Modification Bulletin

Model: SR210 (Finisher for AD1) Date			e: 30-Jun-97	No: 001	
Modified Article: Main Control Board			Prepared by: M.Horiike		
From: QAC 2nd Field Information Dept.					
Reason for	Parts catalog correction	U Vend	or cha	ange 🗌 To	meet standards
Modification:	To facilitate assembly	🗌 To im)		
	Part standardization	Other

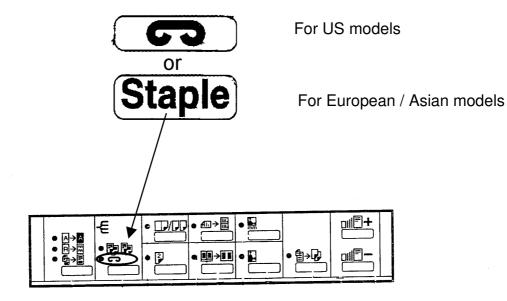
The following decal is missing. Please add this part to your part catalog.

After installing an SR210 on an AD1 or AD1E, this decal must be put on the operation panel as shown below.

Old part number	New part number	Description	Qty	Int	Page	Index
	A6664940	Decal – Stapler	1

2. ENTRANCE SECTION (A666)

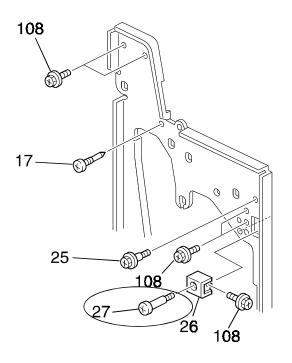
The index no. 27 on page 5 of the parts catalog is not mentioned. Please add the following part to your parts catalog.

Part		Index
No.	Description	No.
A6661419	Stepped Screw – M4 x 6	27
